PRODUCT/PROCESS CHANGE NOTICE (PCN)

PCN #: A0508-01 DATE: 10/10/2005 Product Affected: Green 28L TSOP (PZG28) package Date Effective: 1/9/2006	MEANS OF DISTINGUISHING CHANGED DEVICES: <input type="checkbox"/> Product Mark <input checked="" type="checkbox"/> Back Mark Encrypted "A" prefix on the assembly lot number. Refer to Attachment 2. <input type="checkbox"/> Date Code <input type="checkbox"/> Other
--	---

PCN Type: Change in assembly location from Chippac/Stat-China to OSE-Taiwan for green 28L TSOP (PZG28) package.

Illustration of the foot length

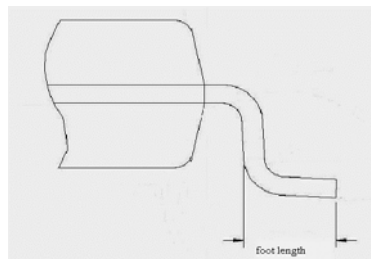
Detail of Change: IDT have completed the qualification to change the assembly location of the green 28L TSOP (PZG28) package from Chippac/Stat-China to OSE-Taiwan. The 28L TSOP from OSE-Taiwan have a slightly shorter foot length. Please refer below for the details. There is no change in the lead tip-to-lead tip length of the package.

There is no change to the existing Moisture Sensitive Level (MSL). There is a change to the Datasheet for the foot length dimension as below :-

Description	From	To
Assembly Location	Chippac/Stat-China	OSE-Taiwan
Foot Length range (min - max)	0.5 - 0.7 mm	0.3 - 0.7 mm

Illustration of
Encrypted 'A' prefix on the assembly lot number

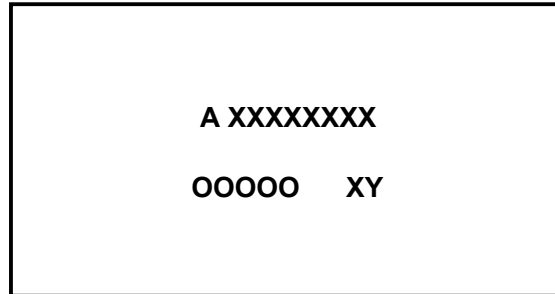
A	= OSE-Taiwan built
XXXXXXXX	= Assembly Lot Number
OOOOO	= Country of Origin
XY	= mold date code
